SUNDRY NOTICES AND REPORTS ON WELLS
Do not use this form for proposals to drill or to re-enter an abandoned well. Use form 3160-3 (APD) for such proposals.

8. Well Name and No.
GALLEGOS CANYON UNIT 202E

PLUG AND ABANDONMENT PROCEDURE

CONDITIONS OF APPROVAL

Proposed WBD

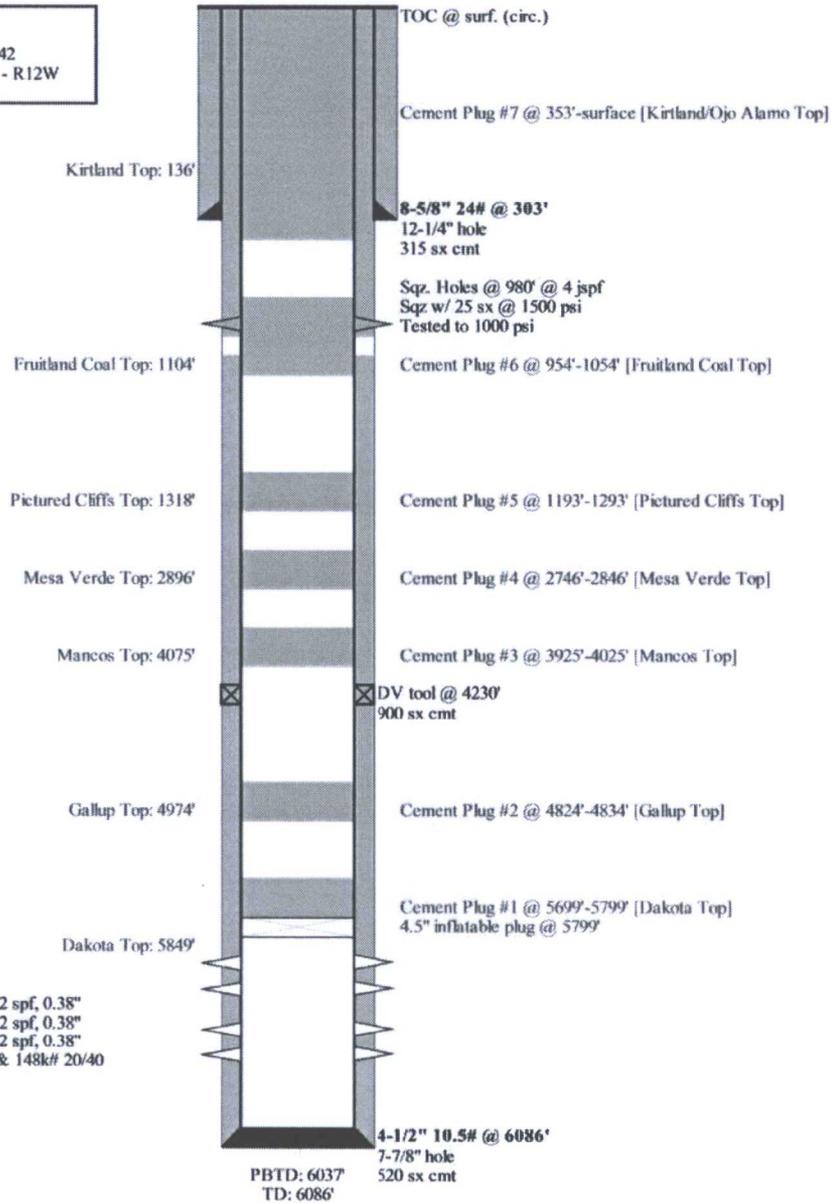
- a) Set Plug #2 (5024-4924) ft. to cover the Gallup top. BLM picks top of Gallup at 4974 ft.
- b) Set Plug #3 (4125-4025) ft. to cover the Mancos top. BLM picks top of Mancos at 4075 ft.
- c) Set Plug #4 (2929-2829) ft. to cover the Mesaverde top. BLM picks top of Mesaverde at 2879 ft.
- d) Add a cement plug (2346 – 2246) ft. to cover the Chacra top. BLM picks top of Chacra at 2296 ft.
- e) Set Plug #5 (1368-1268) ft. to cover the Pictured Cliffs top. BLM picks top of Pictured Cliffs at 1318 ft.
- f) Set Plug #6 (1088-988) ft. to cover the Fruitland top. BLM picks top of Fruitland at 1038 ft.
